# UNITED STATES PATENT AND TRADEMARK OFFICE

| APPLICATION NO. | FILING DATE | FIRST NAMED INVENTOR | ATTORNEY DOCKET NO. | CONFIRMATION NO. |
|-----------------|-------------|----------------------|---------------------|------------------|
| 10/574,090      | 03/30/2007  | Lino Dreyer          | HWR-0183US          | 8930             |

| <b>Office Action Summary</b> | <b>Application No.</b><br>10/574,090 | <b>Applicant(s)</b><br>DREYER ET AL. |  |

## DETAILED ACTION

This figure, now referred to as annotated Fig. 1, used for the rejection of claims 1-14 has been replicated below, and the Examiner has added reference points for ease of explanation, and said reference points will be used for the rejection of claims 1-14 below.

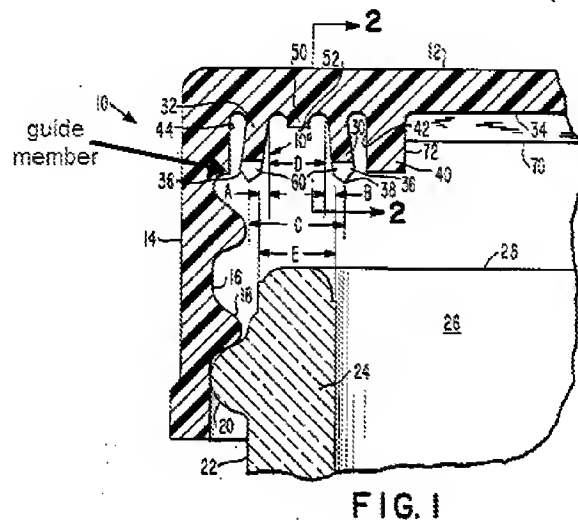
13. Claims 1-14 are rejected under 35 U.S.C. 102(b) as being anticipated by U.S. Patent No. 4,560,077 to Dutt ("Dutt").

As to claim 1, Dutt teaches a plastics closure (closure cap 10) for a container, the closure comprising a top plate (top 12), a side skirt (side wall 14) depending from the periphery of the top plate (Fig. 1), a sealing strip (outer sealing flange 32) depending from the top plate, a sealing strip depending from the top plate and adapted to sealingly engage the side of a container neck finish (container neck 24), and an abutment member (outer seal flange abutment surface 44) including a projecting guide member (guide member, annotated Fig. 1) for guiding the sealing strip towards the neck finish as the closure is applied, so that the strength of the seal is increased, wherein the guide member contacts the sealing strip over a relatively small area so that the friction between the

sealing strip and the abutment member is minimized and wherein the sealing strip is inclined radially towards the neck finish for improving the sealing effect (Fig. 1).

As to claim 3, Dutt teaches a closure according to claim 1, wherein the surface of the free end (free end 36) of the sealing strip tapers sharply (Fig. 1).
